Newcastle Inner City Bypass – Rankin Park to Jesmond

Modification report: additional construction compounds

Submissions report

September 2021

Figure 2.1

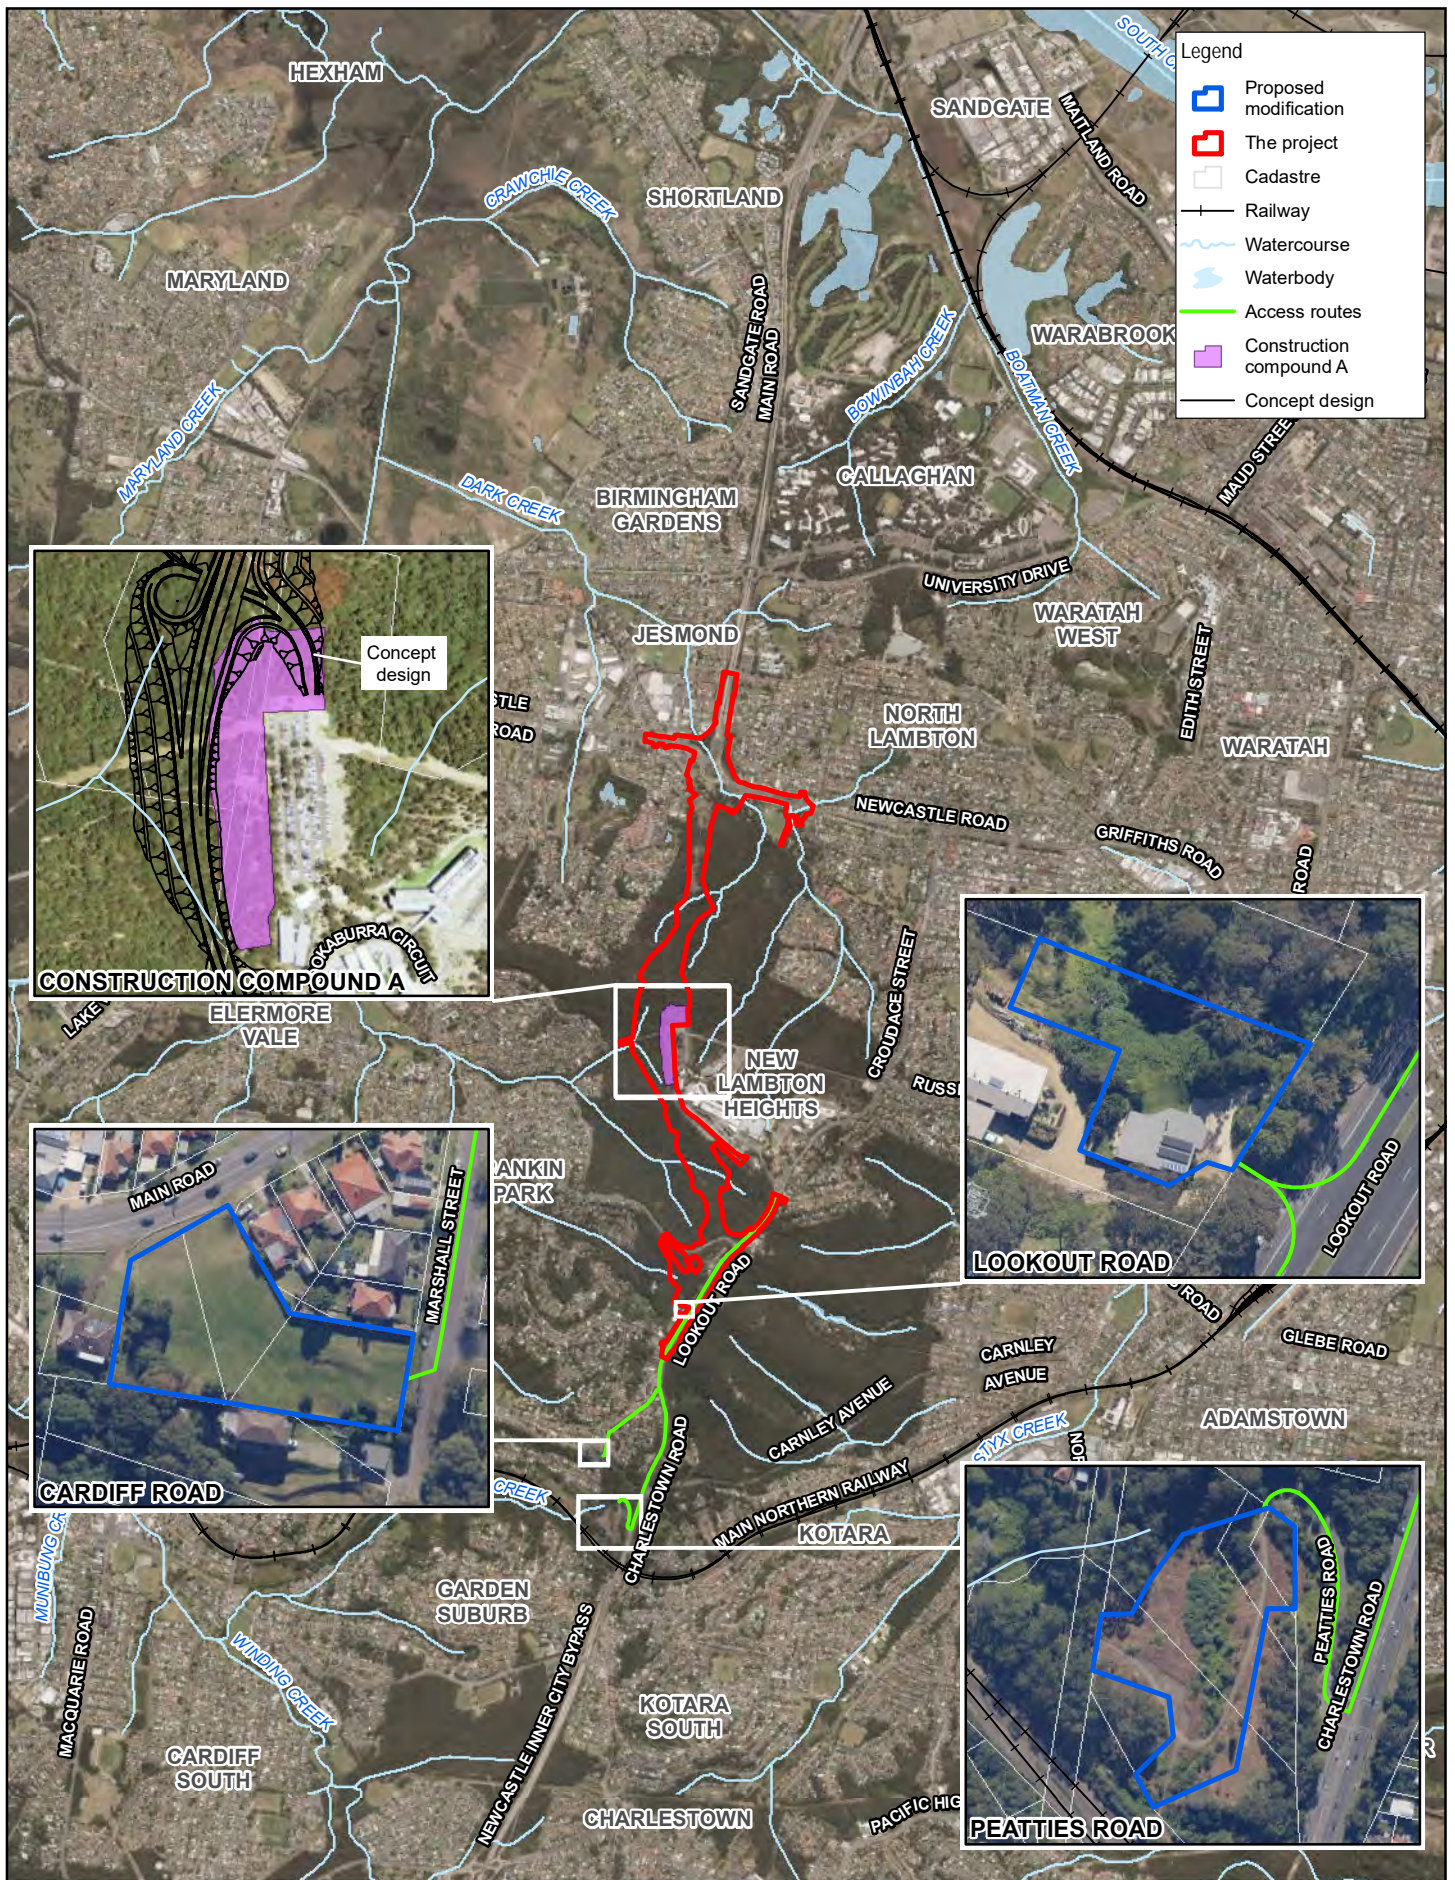
While consultation was carried out with City of Newcastle during the development of the modification report, City of Newcastle have provided further advice that the Astra Street site is no longer available for use by Transport. City of Newcastle raised concern that the proposed use of the site would impact on the Council's current use of the site. The site is also subject to an approved voluntary management proposal issued under Section 17 of the *Contaminated Land Management Act 1997*. While the timing for the remediation program has not been confirmed, City of Newcastle advised that the site would not be remediated until at least the fourth quarter of 2023, and therefore would not be available for use by Transport.

Astra Street site is no longer proposed to be used as a compound site. An updated proposed modification overview is provided in Figure 2.1.

Figure 4-1

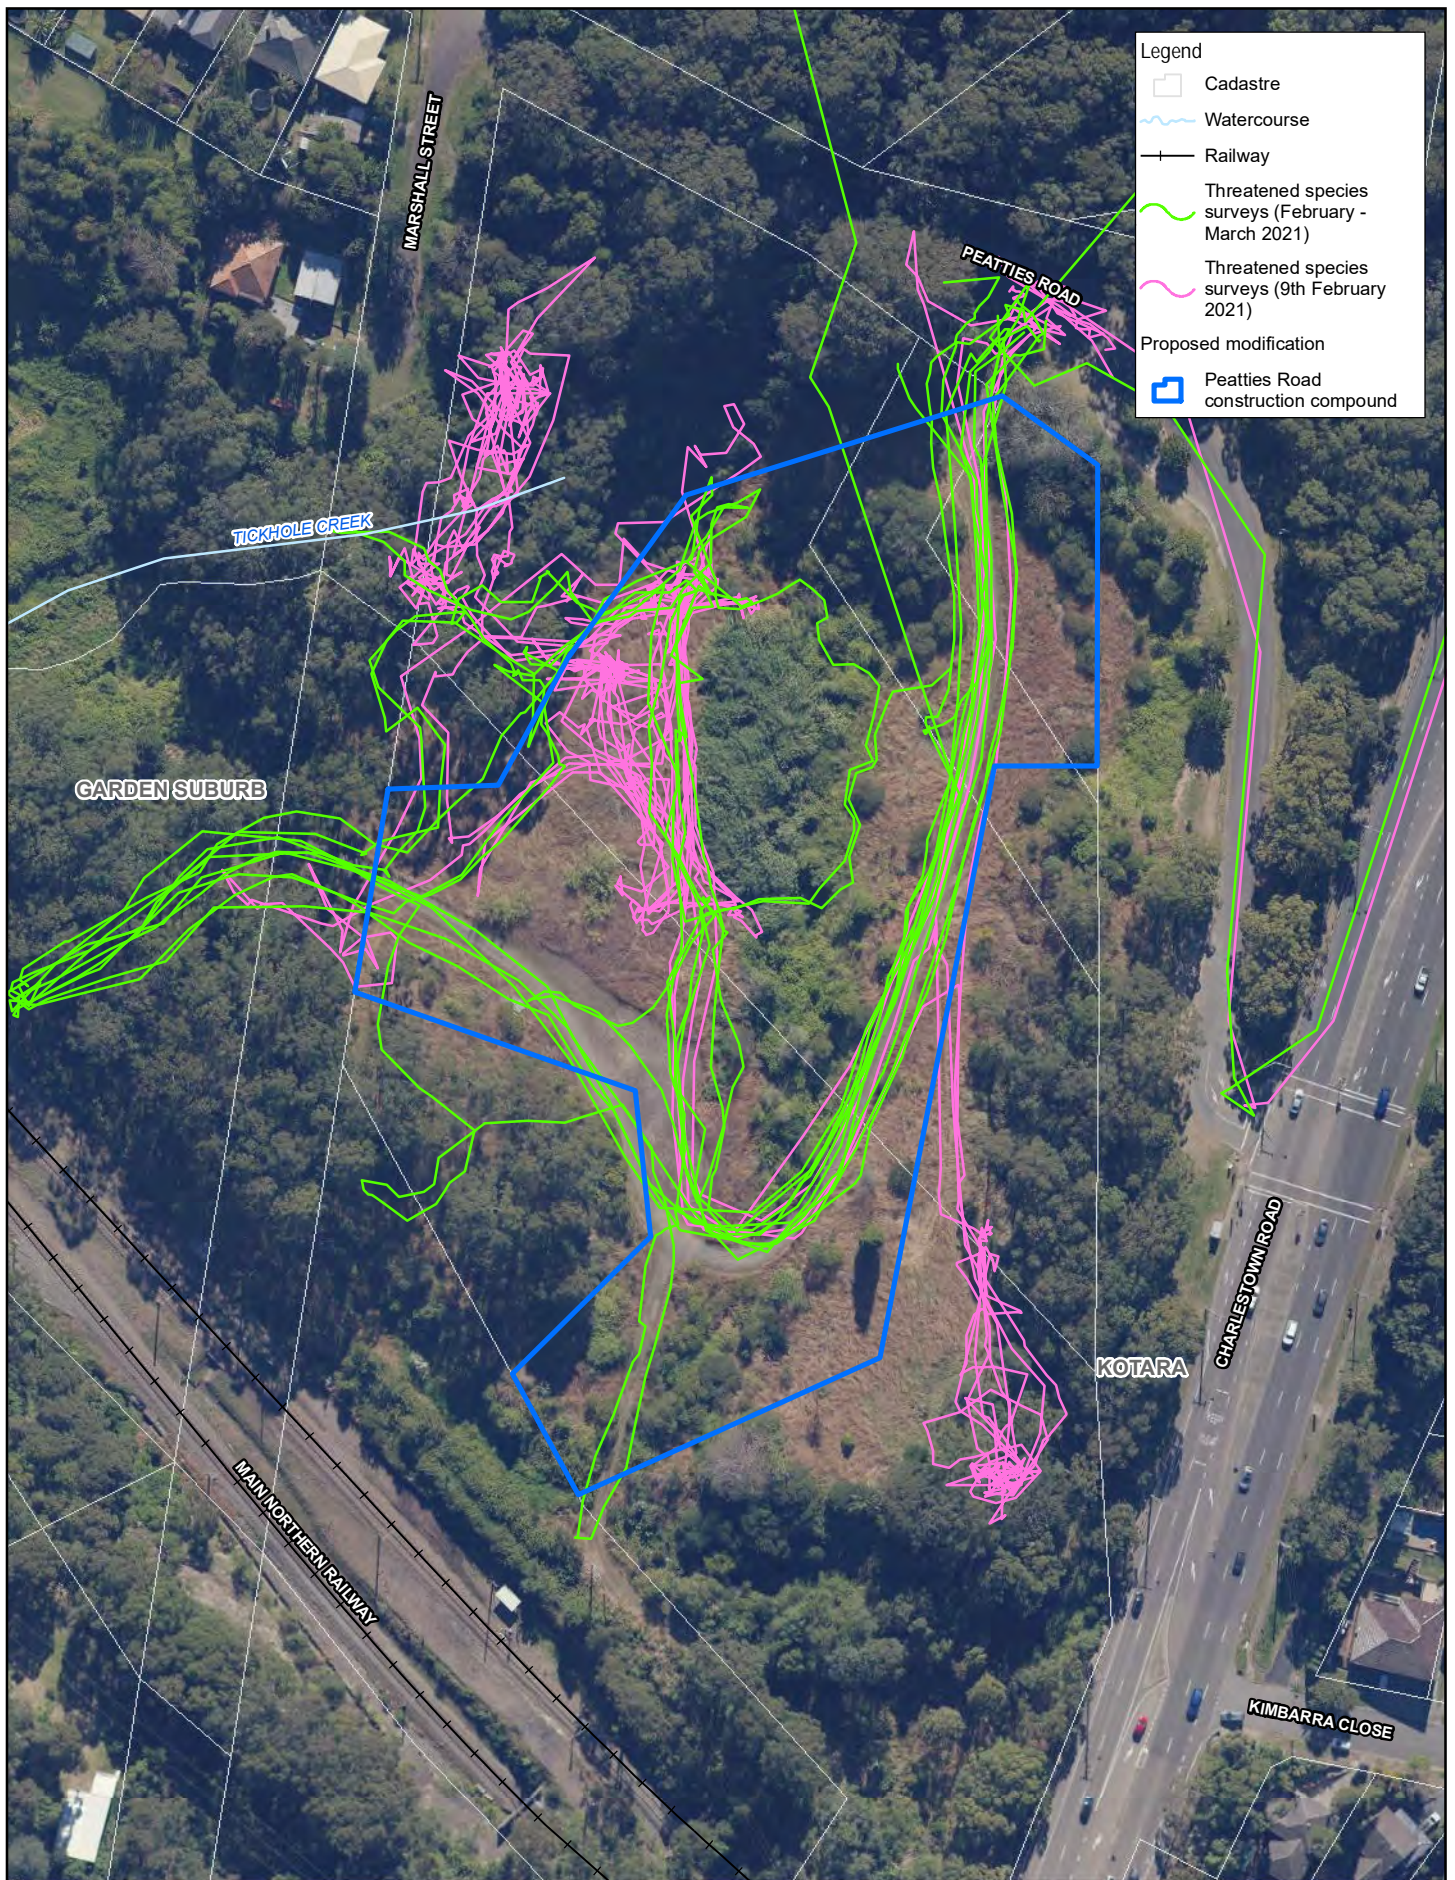
- Biodiversity Conservation Division, DPIE asked for clarification on the extent of flora survey at the Peatties Road site and how *Maundia triglochoides* has been considered

As identified in Section 5.2 of the BDAR two threatened flora surveys (Table 5-3) were completed in accordance with methods described in *Surveying threatened plants and their habitats NSW survey guide for the Biodiversity Assessment Method* (DPIE 2020). An initial random meander survey was completed on 9 February 2021 to collect vegetation plot data. A further site survey was carried out on 24 February 2021. This survey included opportunistic observations for threatened flora and fauna. These surveys did not detect any *Maundia triglochoides* and determined that site is unlikely to provide suitable habitat for this species. Figure 5.1 in the BDAR has been updated as Figure 4.1 below.

Figure 5-1

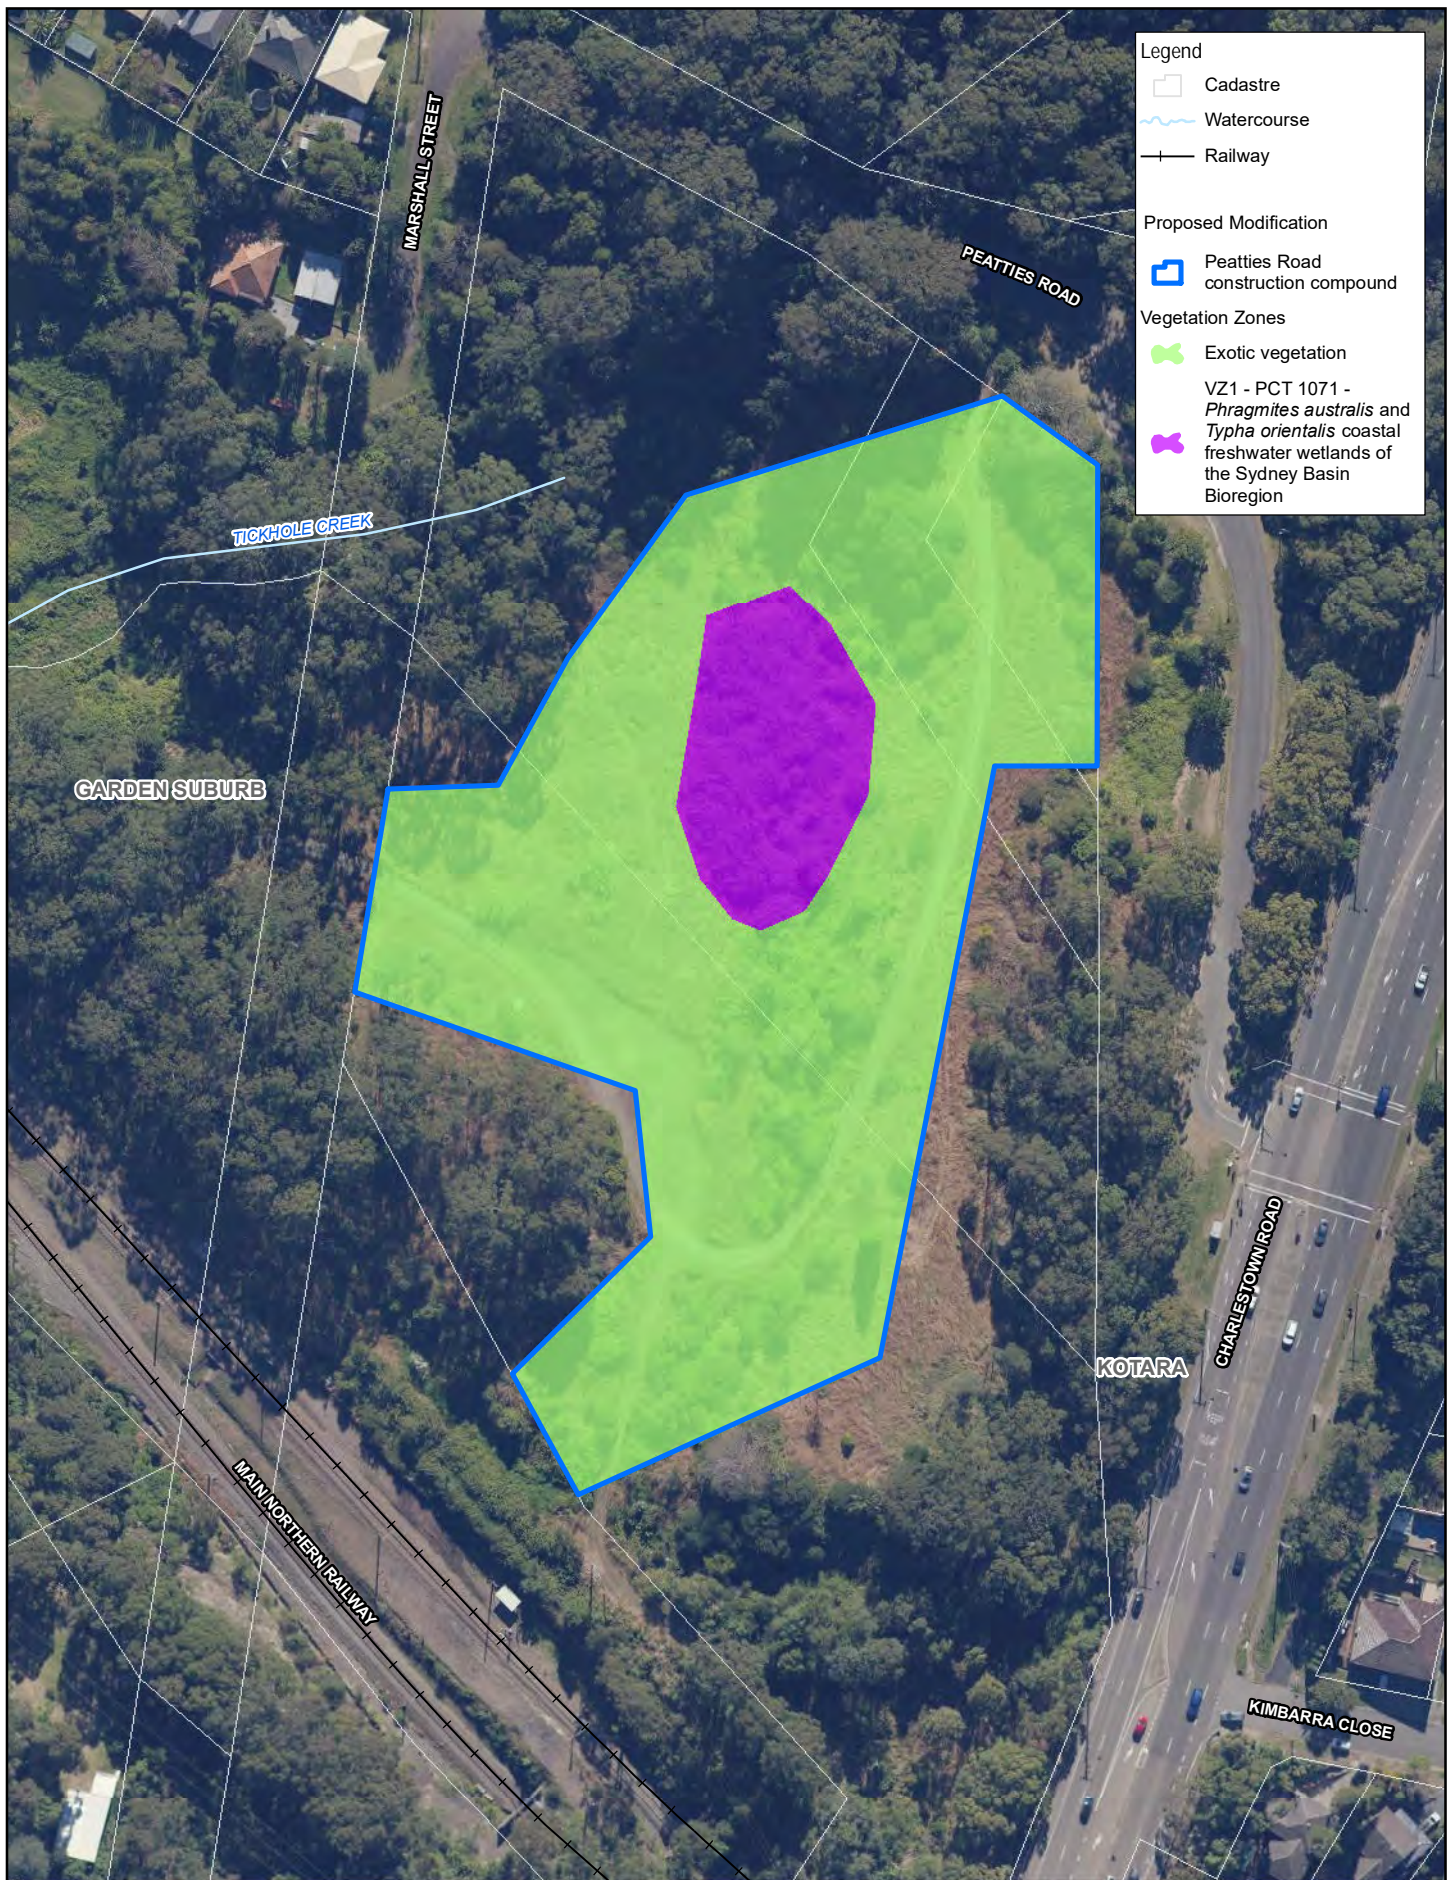
- Requested details on the trees to be removed
- Noted that the Plant Community Type (PCT) at Peatties Road is incorrect
- Commented that the modification report does not address weed management

The area of each compound site proposed to be used are shown in figures 4.1a to 4.1d of the BDAR. The area to be used within Peatties Road compound site is also included in Figure 5.1 of this report. The BDAR is provided as Appendix D to the modification report. Tree removal would be limited to within those areas, with tree protection measures provided in accordance with environmental mitigation measures detail in Appendix H of the modification report.
